Environmental Planning Commission

Agenda Number: 06
Project Number: 1008444
Case #s: 13EPC-40160
February 13, 2014

Staff Report

The Planning Department requests an Environmental Planning Commission (EPC) recommendation to City Council to approve text amendments to the Volcano Trails Sector Development Plan (SDP).

Exhibit 6, Proposed Volcano Mesa Road Network

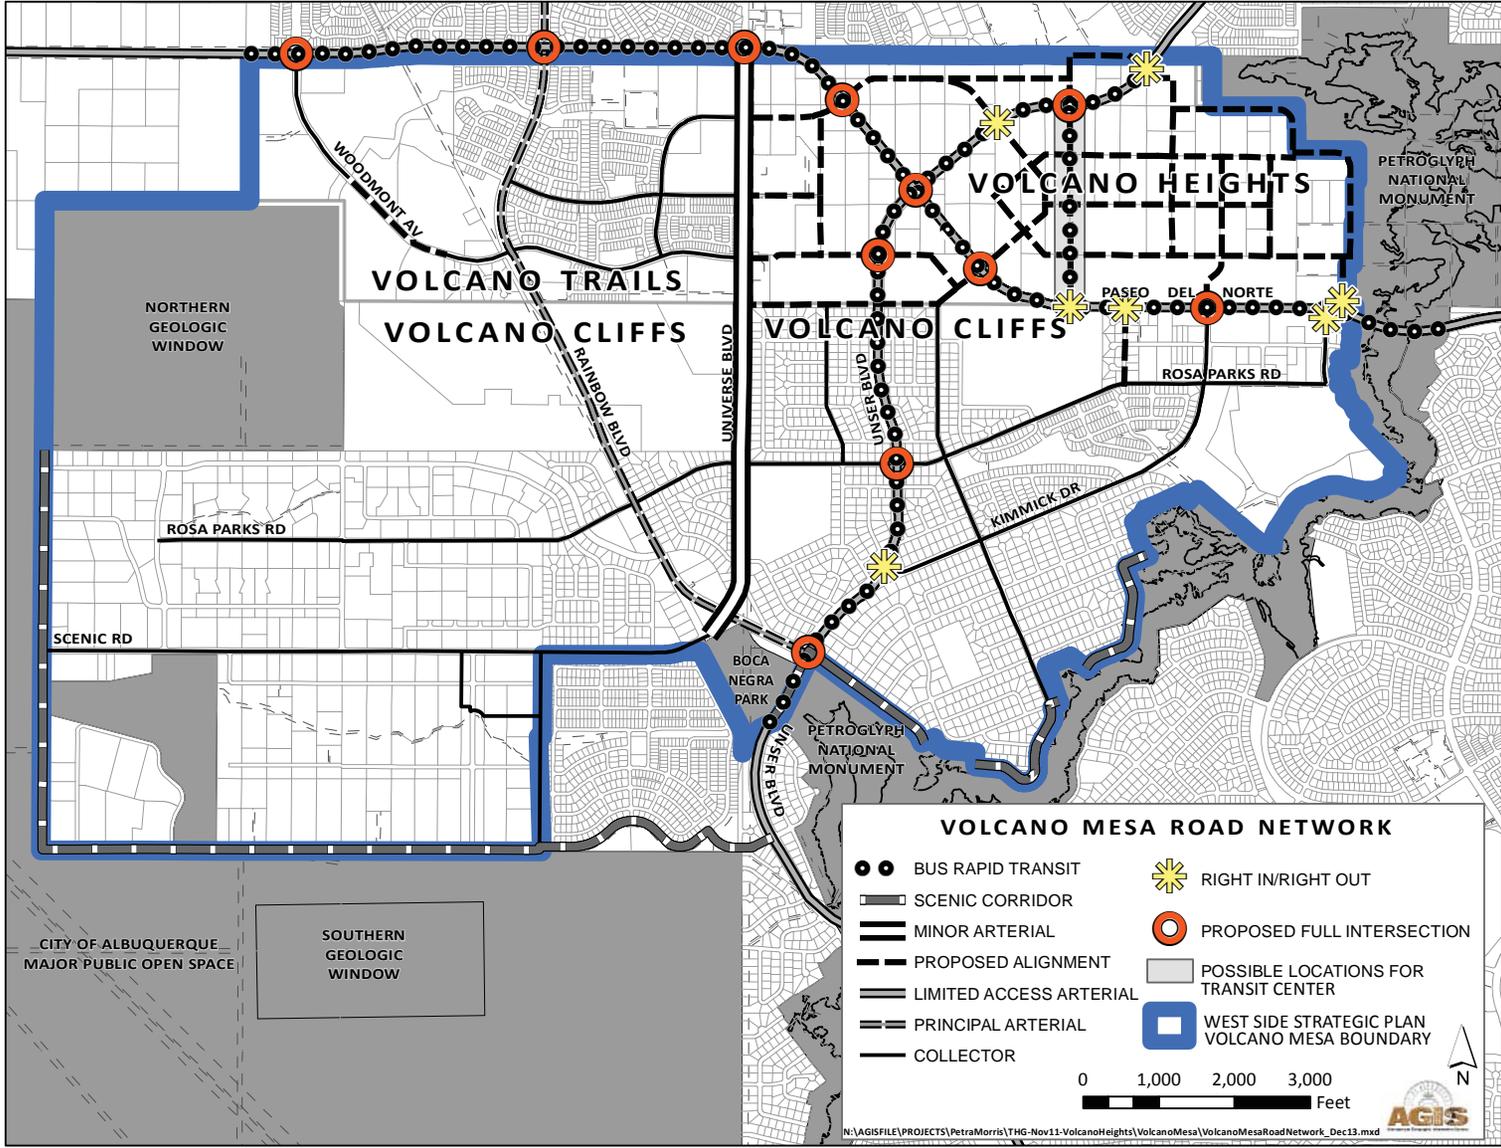
- 1) On page 7: Update road network map with Primary Streets and intersections as adopted in the Volcano Heights SDP.

-
- *Following the original intent of the Volcano plans, this change provides a consistent road network for Volcano Mesa, incorporating streets in the Volcano Heights SDP as well as updates made to access points on the limited-access Paseo del Norte and Unser Boulevard through the Metropolitan Planning Organization.*

1. On page 7, Exhibit 6, in the Volcano Mesa roadway network map, change the symbol at the southern terminus of Transit Boulevard to indicate a full-access, signalized intersection. Delete “proposed” from the caption. [1]
2. On page 6, Exhibit 5 and page 7, Exhibit 6, change the designation of Woodmont Ave. to a minor arterial. [2] & [31]
3. On page 6, Exhibit 5, in the Volcano Mesa roadway network map, update the legend to delete “proposed” where it appears. [3]
4. On page 42, II – General Standards, Utilities, add a new section “3. General” as follows [32]:

Exhibit 10, Zoning Established by the Volcano Trails Sector Development Plan

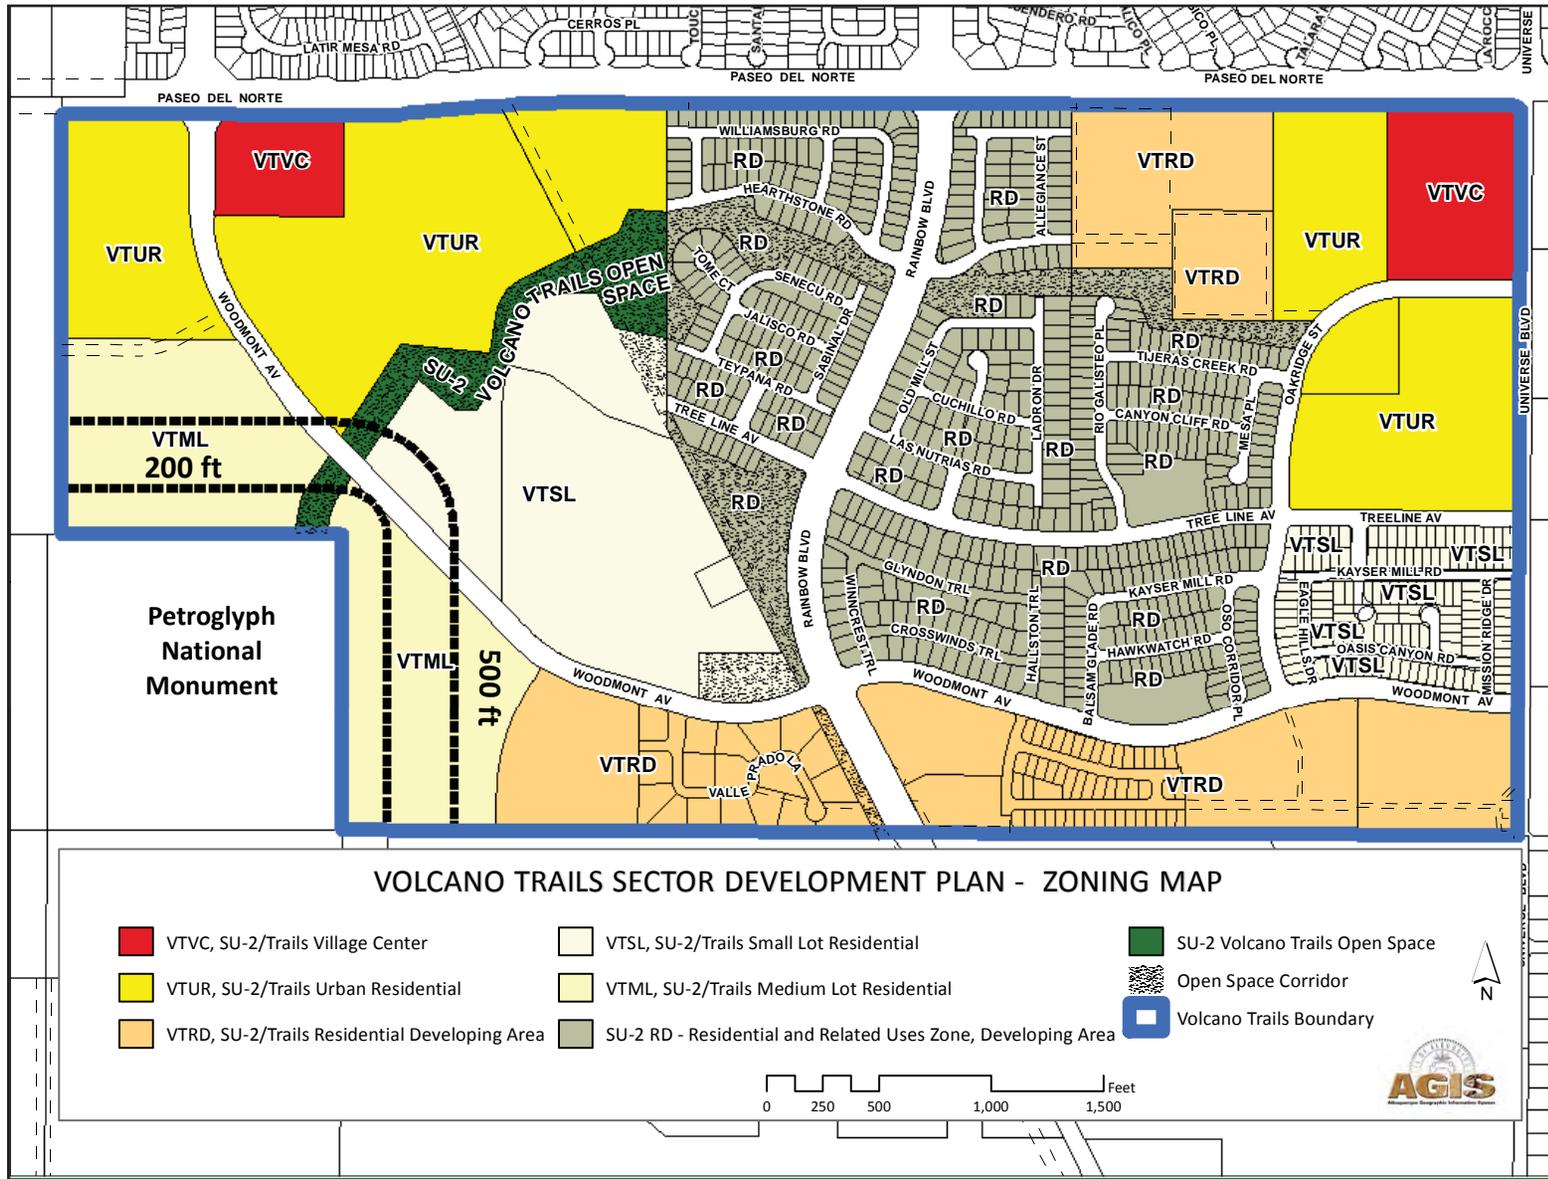
- 2) On page 24: Fix the label for the area west of Rainbow Blvd. and south of Woodmont Ave. colored light orange. The color of the map correctly designates the area as SU-2/VTRD, but the label is incorrect as “RD.”

- *This change fixes an inadvertent error in the original Plan.*
 - 3) On page 40: Add language exempting solar panels from height restrictions.
 - *Height restrictions were intended to limit building height. Solar panels are becoming more common, but they are not yet addressed by the City Zoning Code or this sector plan. The technology is changing fairly rapidly, and it is difficult to anticipate how solar equipment might interface with buildings in the near future. The proposed amendment is intended to clarify that solar panels do not count toward building height*

Exhibit 16, PNM Electric Facilities
[Updated to show Scenic facility]

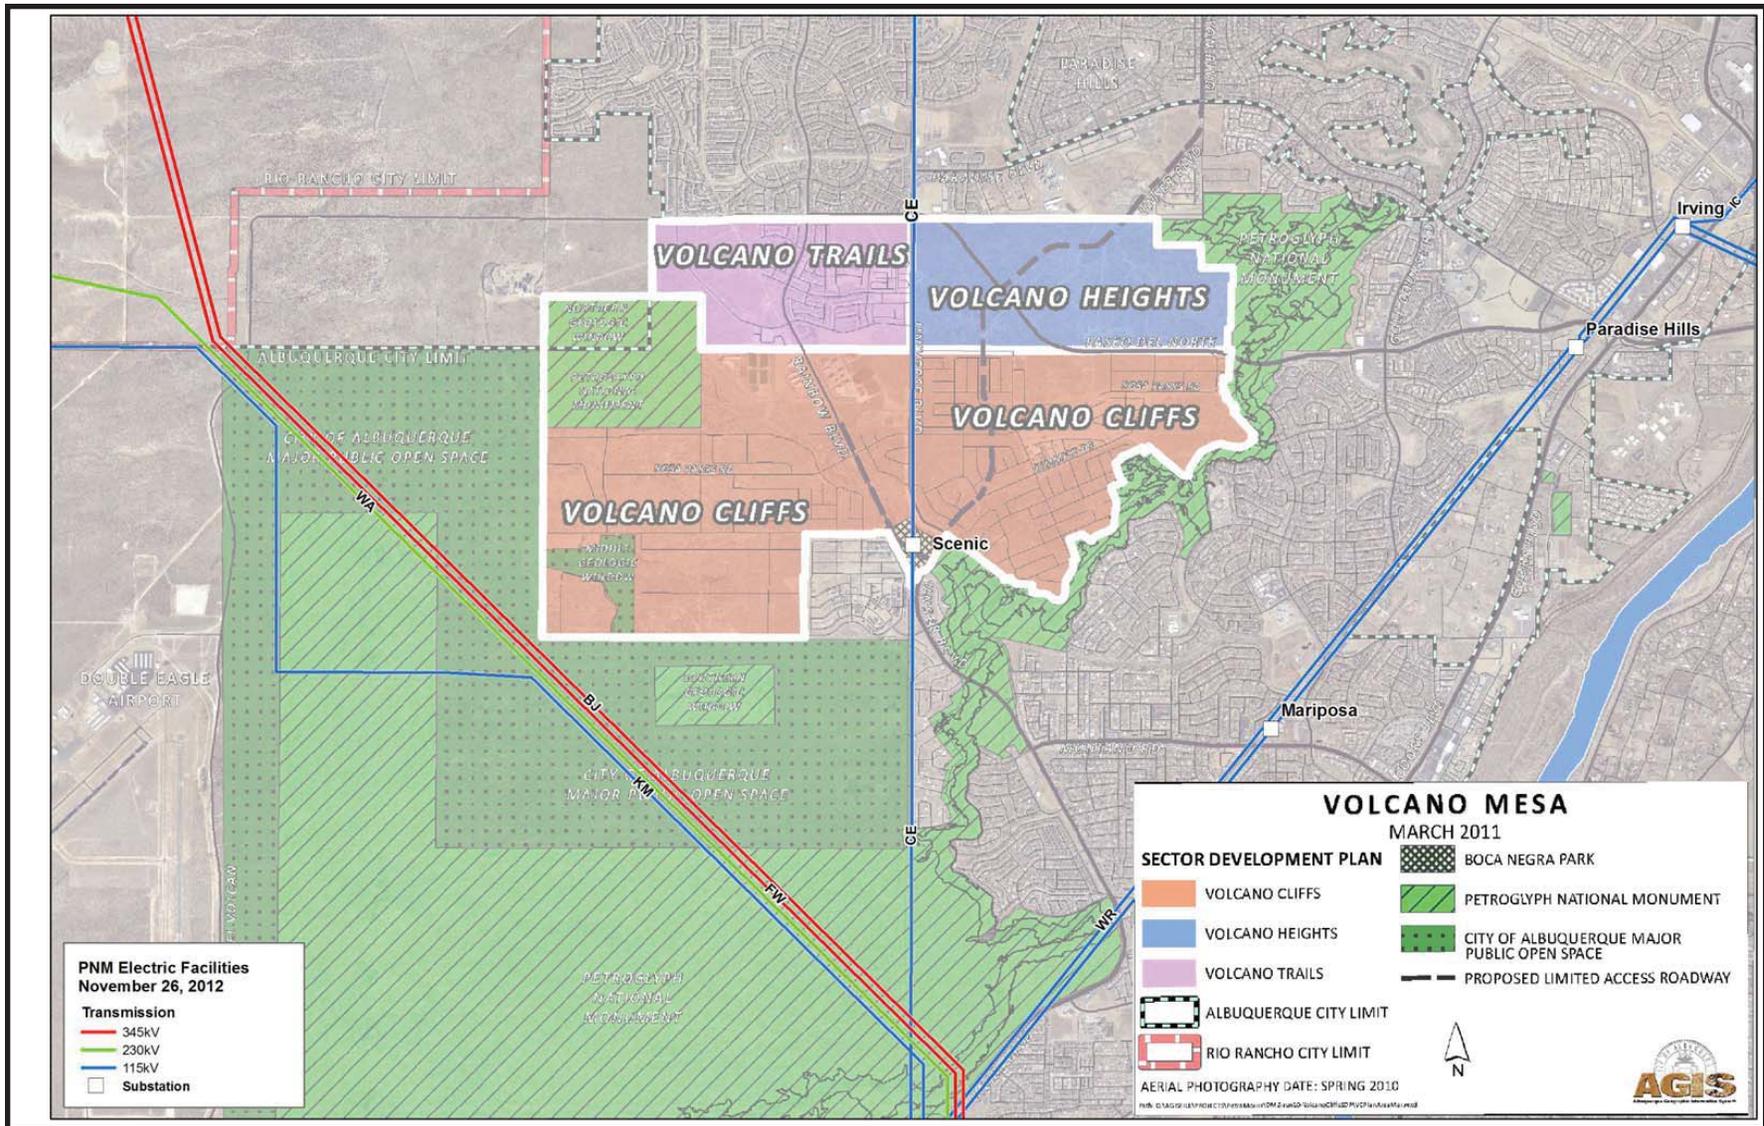
- 4) On page 43: Replace Exhibit 16 with updated graphic from PNM in VHSDP (Appendix A-39).
 - *The map of existing electric facilities in was updated to reflect projects completed after VTSDP’s adoption in 2011. [NOTE: See also agency comments for a request for further updates to the utility language to be consistent with VHSDP.]*

Exhibit 17, Garage Type Diagrams

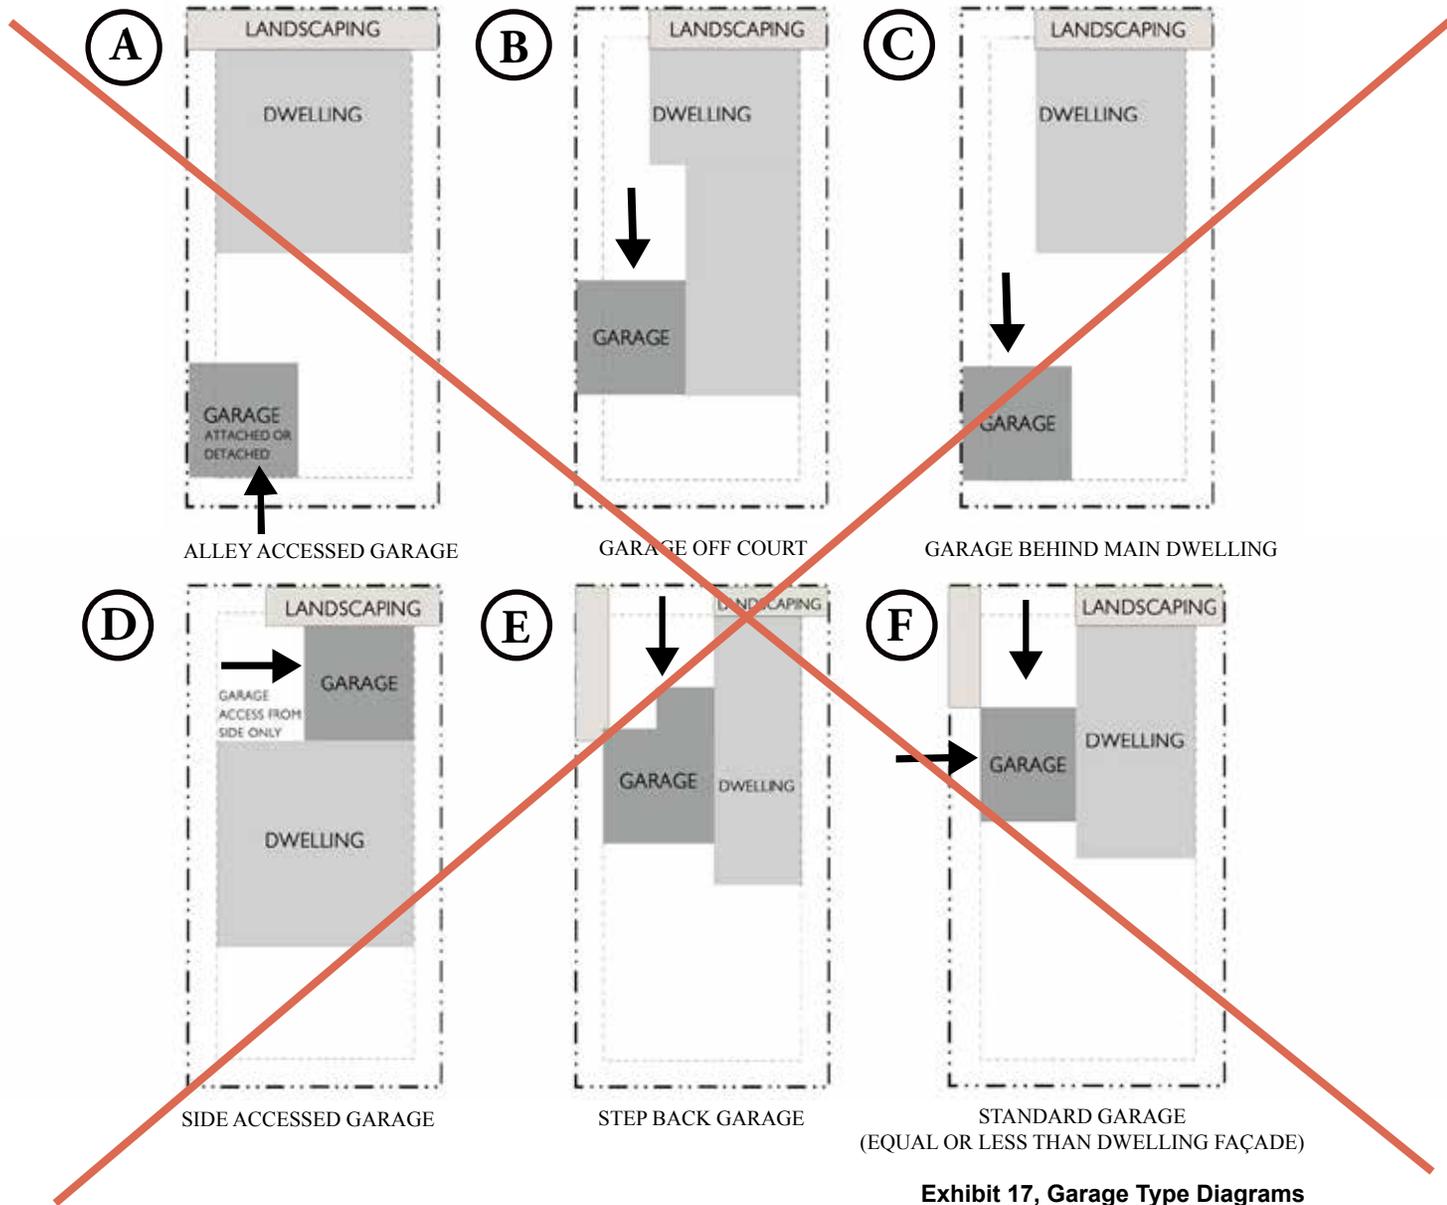
- 5) On pages 46-47: Replace Section 5. Residential Garages in its entirety with language, table, and graphics from Section 7.7 in VHSDP (pages 127-128).

- *Residential garage text and diagrams were revised further for Volcano Heights SDP, partly in response to comments received by developers in Volcano Cliffs and Volcano Trails. The revisions are largely to clarify intent and measurements, as well as reworking graphics to be more understandable as illustrative diagrams (not to scale).*

APPROPRIATE COLORS FROM THE NATURAL LANDSCAPE

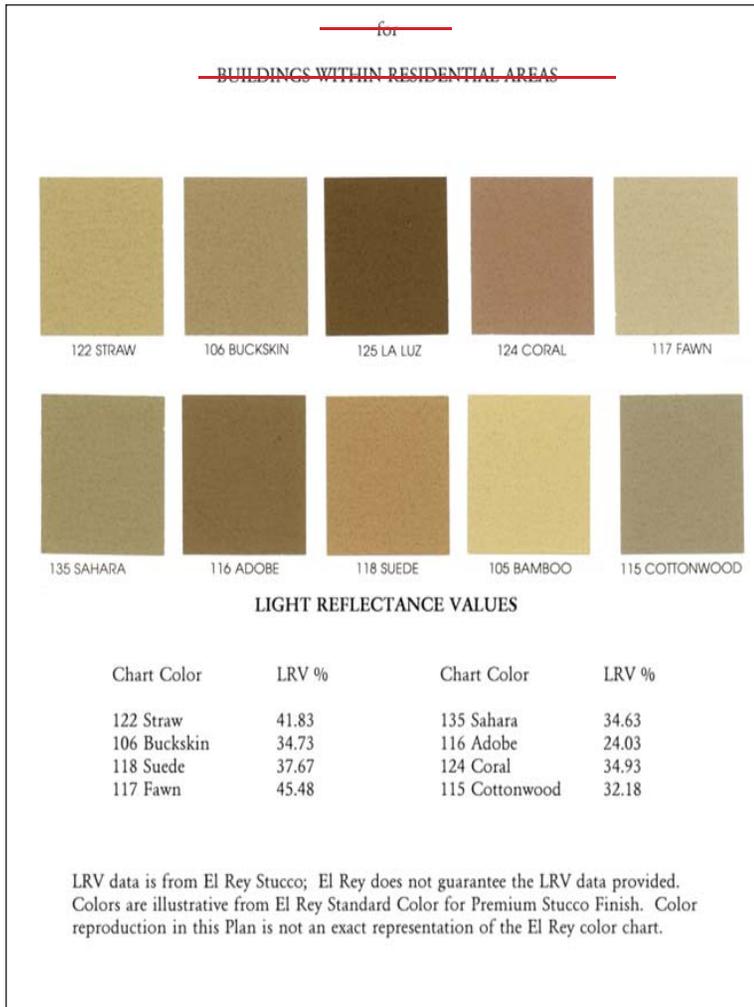
-
- 7) On page 56: “In any residential area” to extend color restrictions to all buildings in Volcano Trails. Add a limit of 20% of the façade area for accent colors per VHSDP Section 7.5.2 (pg. 126).

- *When adopted in 1989, the Northwest Mesa Escarpment Plan (NWMEP) set regulations about color restrictions in the area that now covers all three Volcano plans. According to the National Park Service and City Open Space Division, it was their intent to restrict color on residential buildings, including walls and roofs, although the final regulations only pertain to roof color. Further, when it was developed, the NWMEP envisioned primarily residential development in this area, as the zoning was predominantly for single-family uses at that time. Now that the Volcano plans have diversified zoning to include nodes of non-residential and mixed-use activity, the restrictions on color are proposed to be extended to these types of development in order to ensure that the original intent of the NWMEP – that development be visually compatible with the natural environment – is still met. The color restrictions are intended to preserve views into and from the nearby Petroglyph National Monument and City Major Open Space, as well as to the area from east of the Rio Grande, by minimizing the visual impact of development.*

~~In any residential area,~~ Exterior building colors shall have a “light reflective value” (LRV) within the range of 20% to 50% LRV rating. Stucco and other materials with colors similar to those illustrated in **Exhibit 18** may be used, as long as they have integral color and meet the standards for reflectivity and harmony with the natural landscape. (See **Chapter 3 Section II – General Standard B.1.** for more details about Exterior Finishes permitted by the Plan.)
